**CITY OF PORT LAVACA – CITY HALL MASTER PLAN
PHASE 3 – INTERIOR RENOVATIONS AND SITE WORK**
202 N. VIRGINIA ST.
PORT LAVACA, TEXAS 77979
PROJECT #1043-1123

ADDENDUM NUMBER ONE

NOVEMBER 1, 2024

A1.2

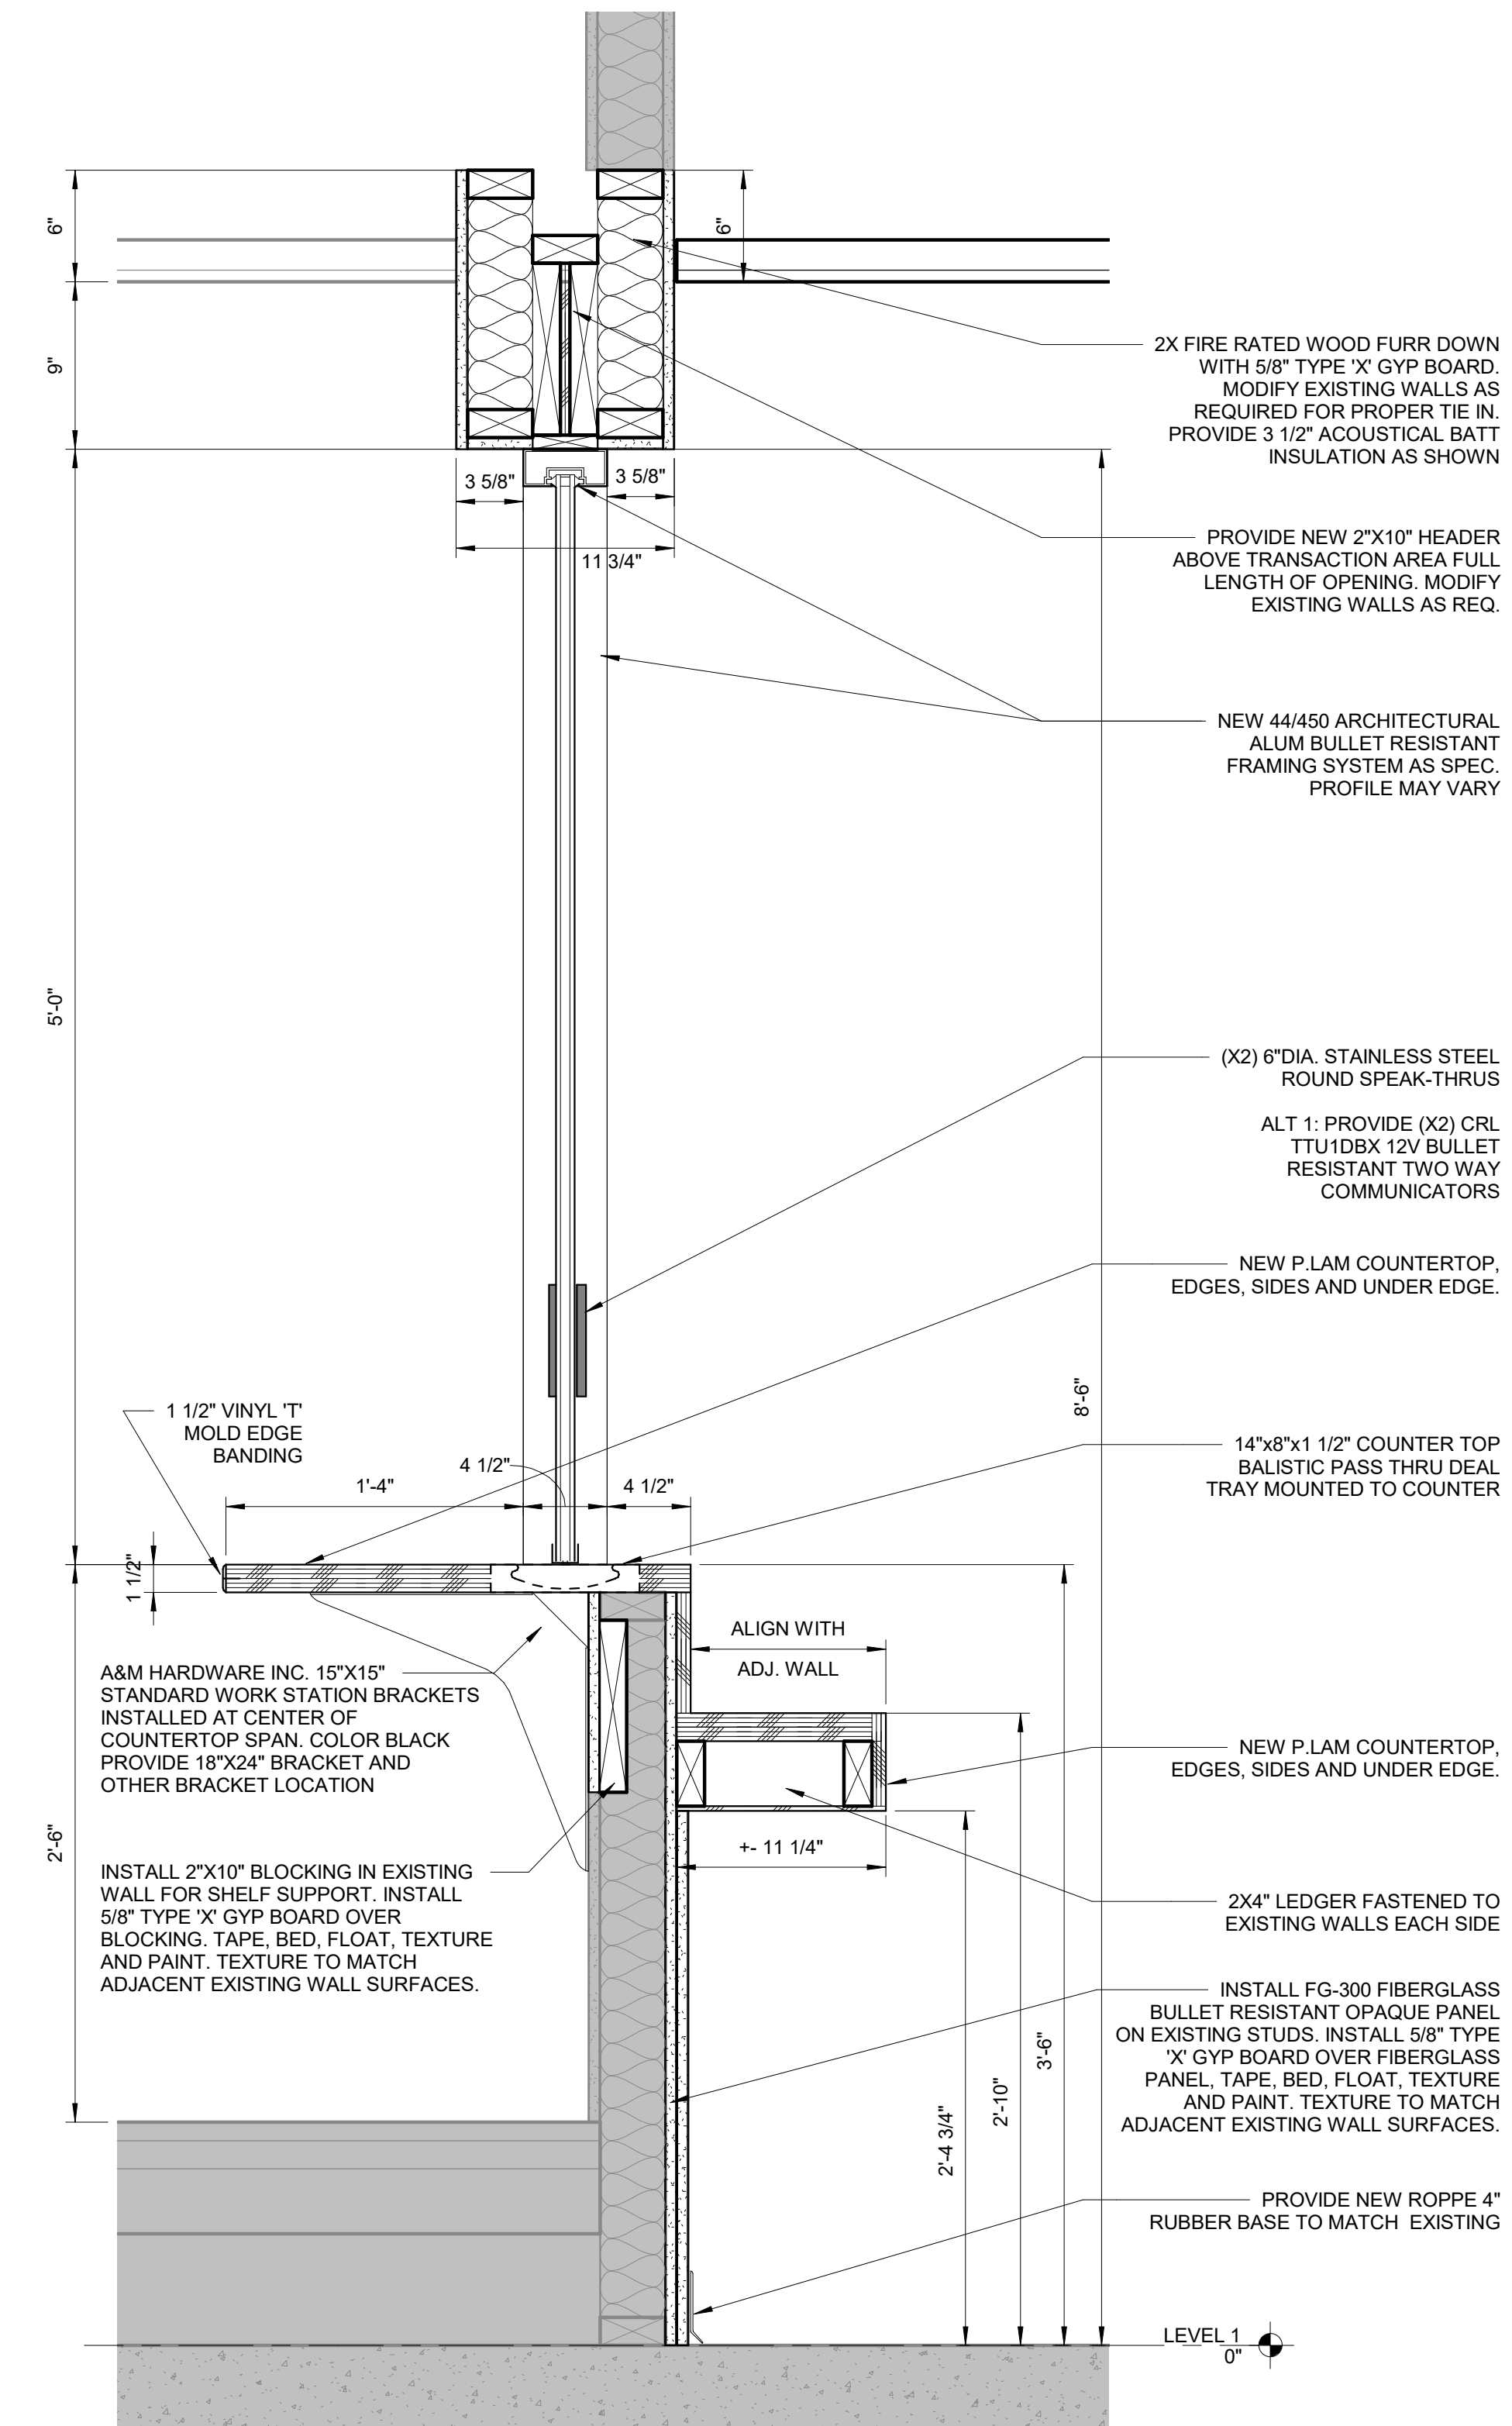
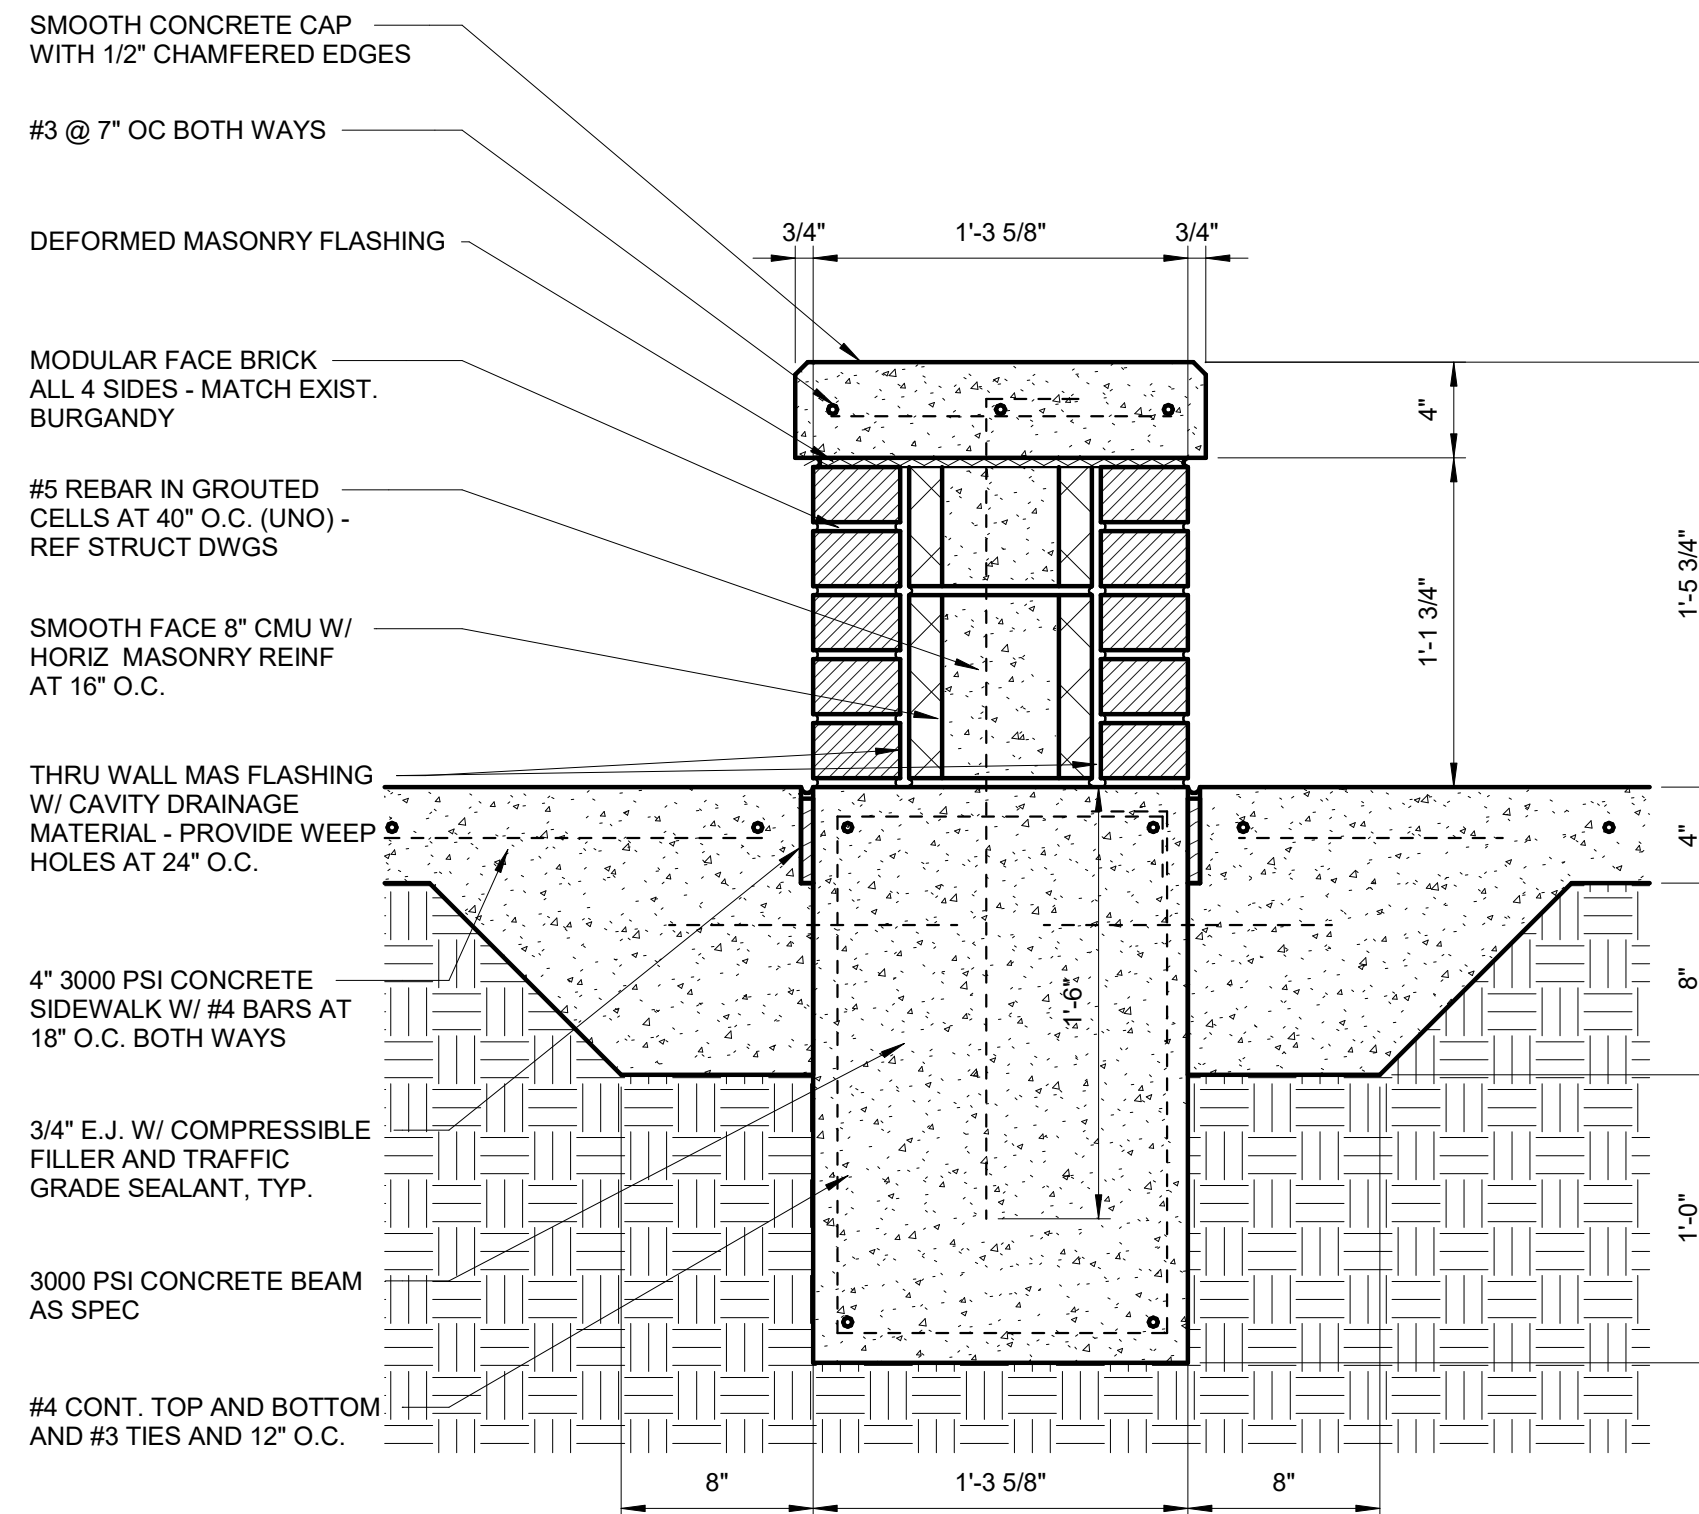
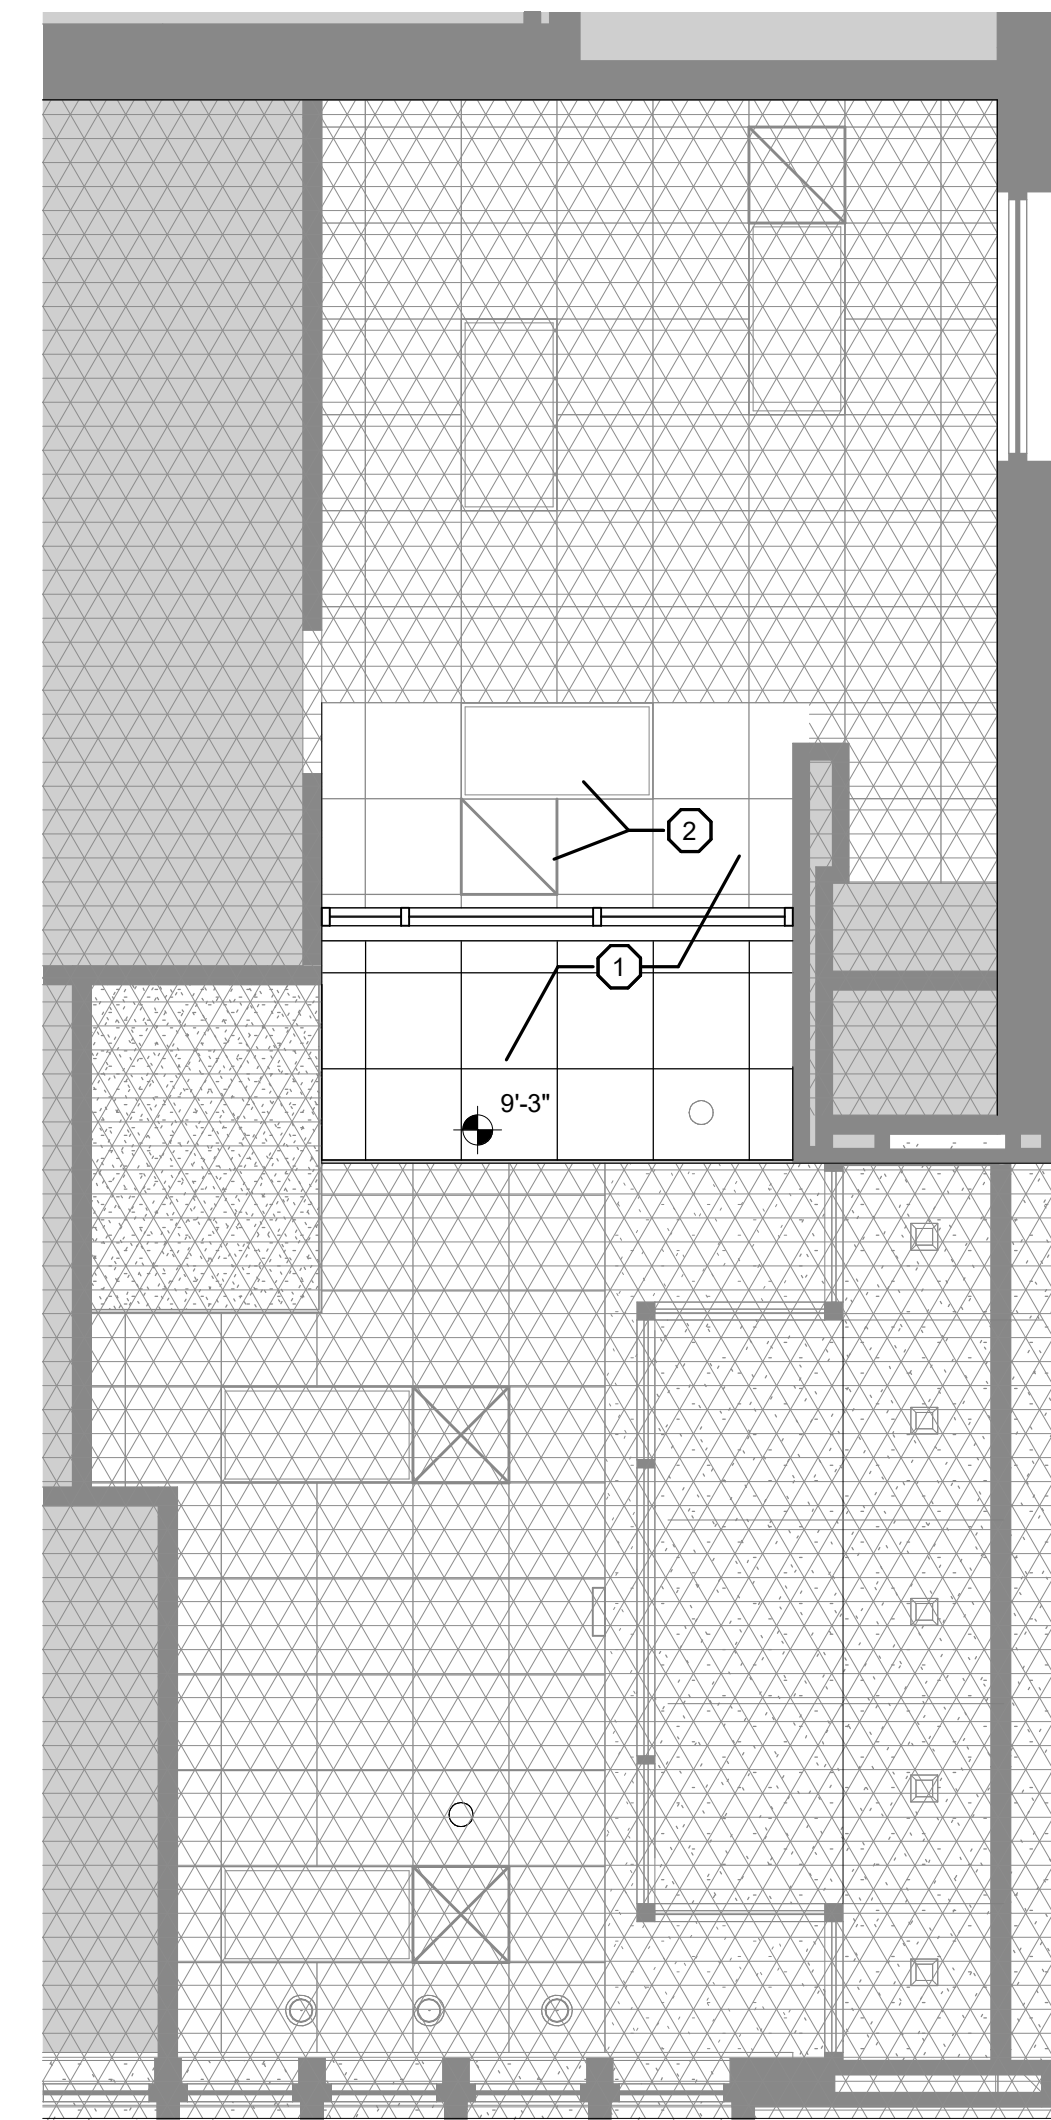
1. A1.1 DEMO PLAN, FLOOR PLAN, AND WINDOW ELEVATIONS
2. A1.2 RCP, WALL SECTIONS & DETAILS
